THE CANARD PUSHER

No. 47

January 1986

PLANS CHANGES.

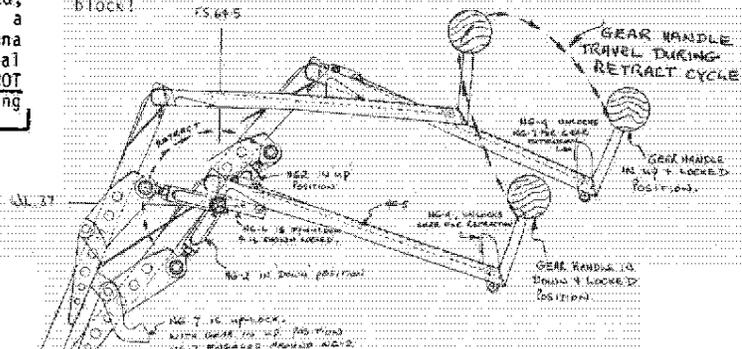
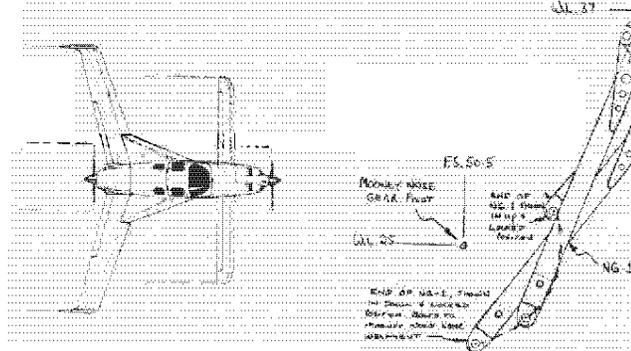
This drawing shows the motion of the Defiant nose gear retraction mechanism. A number of Defiant builders have had difficulty visualizing just exactly how this works. Actually, it is very simple. The NG-2 arm must be swung through an arc of about 190°. The central pivot of this arc is at W.L.37 and F.S.64.5. To do this, the gear handle moves up and forward, then swings back and down, see below. The NG-4 finger operated lever operates the gear down lock NG-6 and also the gear up lock, NG-7. Hopefully this will clarify this area for any builders still having a mental block!

NOTE: DISTANCE BETWEEN PIVOTS (F.S.64.5) AND (F.S.64.5, W.L.37) SHOULD BE APPROXIMATELY 18.4". THIS DIMENSION IS RELATIVELY CRITICAL.

WHEN GEAR DOWN & LOCKED, NG-6 IS SPRUNG AGAINST NG-2 BUSHING. FOLLOWING RET. ON NG-4 FULL NG-6 UP & UNLOCKS NOSE GEAR. HANDLE IS THEN SMOOTHLY LIFTED THROUGH THE ARC SHOWN, WHICH ALLOWS NG-2 BUSHING TO PIVOT THROUGH APPROXIMATELY 190° AT F.S.64.5 AND W.L.37. MOONEY NOSE GEAR PIVOTS AT F.S.50.5. AND W.L.25. THE END OF NG-2 BUSHING IS BOLDED TO FORWARD AXLE BUSH BUSHING. NG-7 IS ACTIVATED BY PULLING DOWN ON NG-4. NG-7 BUSHING ON NG-2 BUSHING TO HOLD GEAR UP & LOCKED. OBSERVE THIS SEQUENCE TO BUREAU DRAW.

SPC # 59 Engine installation plans.

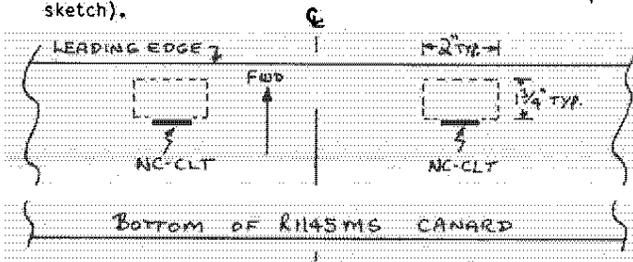
Note: Hydraulic jack oil should be used in the electro-hydraulic engine extension system. Do not use brake fluid. Hydraulic jack oil is obtainable from any auto parts store.

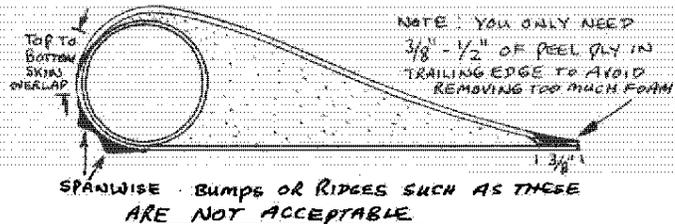
When you build your R1145MS canard, areas to be as accurate as possible with that are sometimes ignored, are the shape of the canard "cove" or trailing edge and the elevator leading edge. These two define the "slot" shape, which is quite critical and should be given your best attention. The lower half of the leading edge of the elevator should be a section of a circle, and smooth. There should be no spanwise bumps or ridges. (see sketch).

R1145MS CANARD

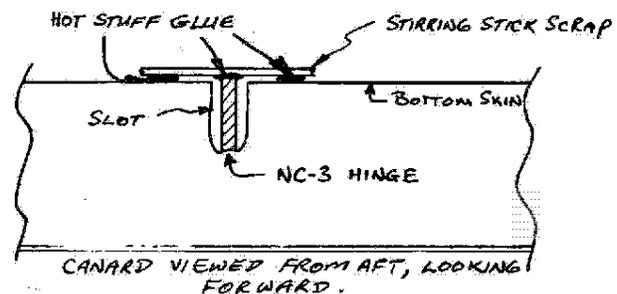
Several builders have reported not being able to get the full 15° of elevator trailing edge up travel. This is very important to assure adequate nose down authority at aft limit CG. The best way to assure that this does not happen to you is to follow the plans as far as jiggling the elevators into position with the NC-3 hinges inserted into the slots in the canard. Do not pour in the wet flox yet! Using scraps of wood stirring sticks (tongue depressors) and Hot Stuff glue, temporarily tack each NC-3 to the canard bottom skin as shown.

Use Hot Shot to kick the Hot Stuff off. (If you don't have a bottle of the thick Hot Stuff and Hot Shot, you really are missing a very handy jiggling tool). You should now have the NC-3 elevator hinges temporarily bonded into position, with the elevators mounted to

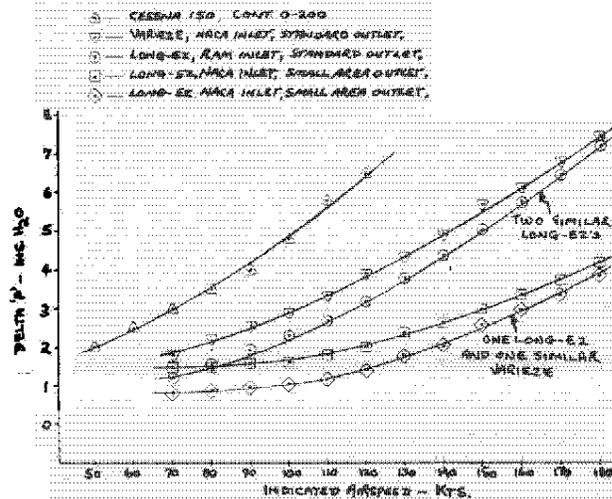
Since most of the incoming air has gone, at high speed, through the aft two cylinders, in most cases overcooling these two cylinders, the forward two cylinders do not get enough cooling air, so it follows that they run too hot. This is the way it is, at least, on the several EZs we have closely examined.

If you accept the above scenario, it follows that a ramp or several ramps installed on the lower cowl, positioned and shaped to deflect the high-speed, incoming, cooling air and cause it to go up and through the forward two cylinders, should do the trick. In all cases we have tested, we have been able to reverse the hottest and coldest cylinders! This is pretty significant and what it tells you is that with some experimenting, you can get all four cylinders running within just a few degrees

OIL TEMPERATURE PROBLEMS

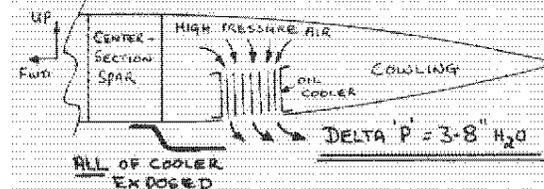
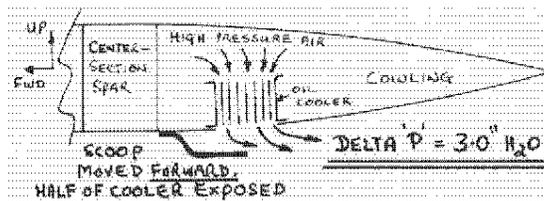
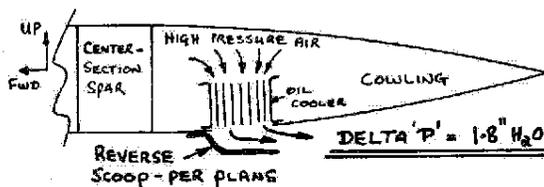
Dick Rutan has been doing a lot of cooling related testing on the Voyager and during his test for optimum oil cooling, he discovered an interesting method to improve cooling air flow through an oil cooler. Using the Voyager water manometer, Dick found that with an oil cooler mounted on the inside of a cowling, such as a Long-EZ does, where the cooler is in the high pressure plenum of the cowl, and vented to the free stream, the following delta 'P' measurements were true.

With NO reverse scoop over the oil cooler (you can see the cooler from outside) the pressure differential was 1.8" of water. He installed a reverse scoop per plans, still 1.8" of water delta 'P'. He moved the reverse scoop forward, exposing half of the oil cooler - 3"H₂O delta 'P'. A dramatic improvement to say the least. Next he moved it forward enough to expose the whole of the oil cooler - 3.8" H₂O Delta 'P', and much cooler oil temperatures. If you are having oil temperature problems in your EZ, try this neat trick

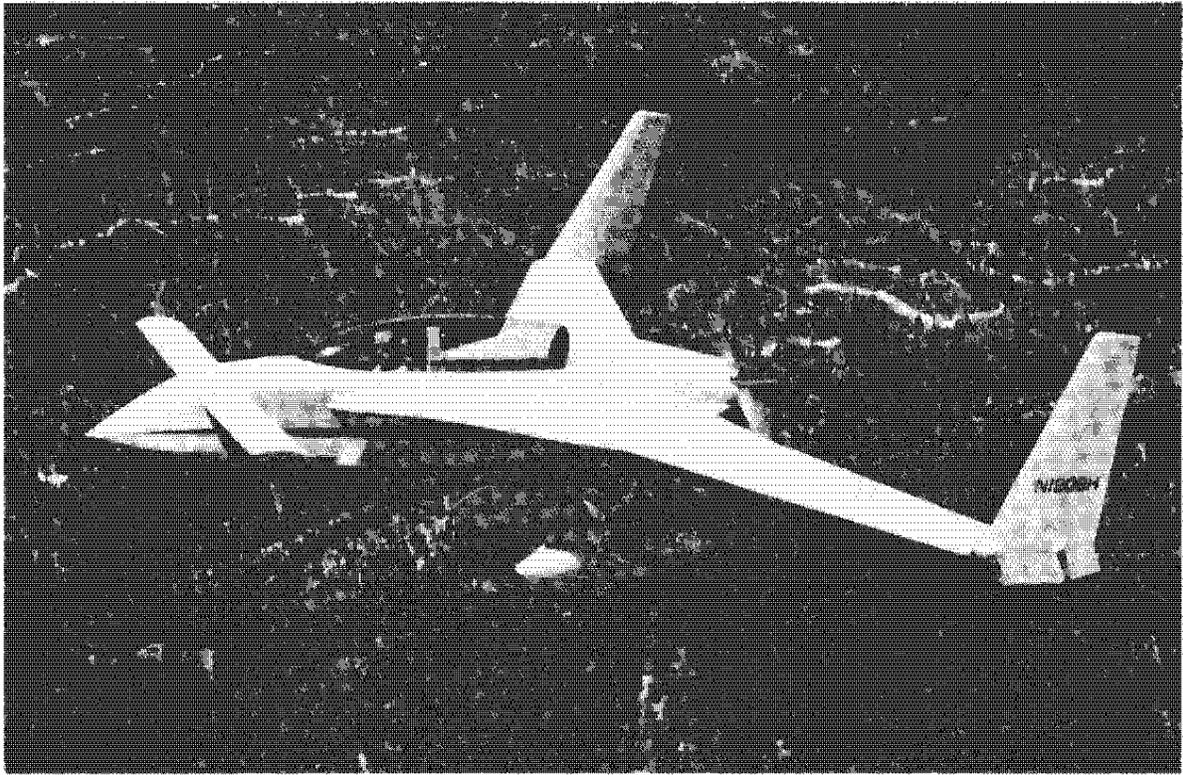
All Long-EZs must have three vortilons installed as shown on the leading edge of each main wing. We have conducted rather extensive testing of vortilons and they definitely do add to the stall margin of a swept wing.

We have included full scale patterns for each vortilon, as well as a plan view and front view showing the positions at which each vortilon should be installed. The main design requirements are that the vortilons are mounted so that they are vertical, relative to the aircraft in level flight, and that they are mounted parallel to B.L.O or the centerline. They do not cant outboard or inboard. The vortilon itself should be made from a six ply BID solid glass layup. The flanges can be two plies of BID on each side of each vortilon.

TAPE SARAN WRAP RELEASE AROUND LEADING EDGE OF WING. LAYUP 2 PLYS OF BID @ 45°, EACH SIDE OF EACH VORTILON. LAP 0-4" ONTO WING. POP OFF AFTER CURE. TRIM, FILL AND PAINT. ATTACH TO WING LEADING EDGE WITH RTV SILICONE. ALLOW TO CURE AT LEAST 24 HRS BEFORE FLIGHT.
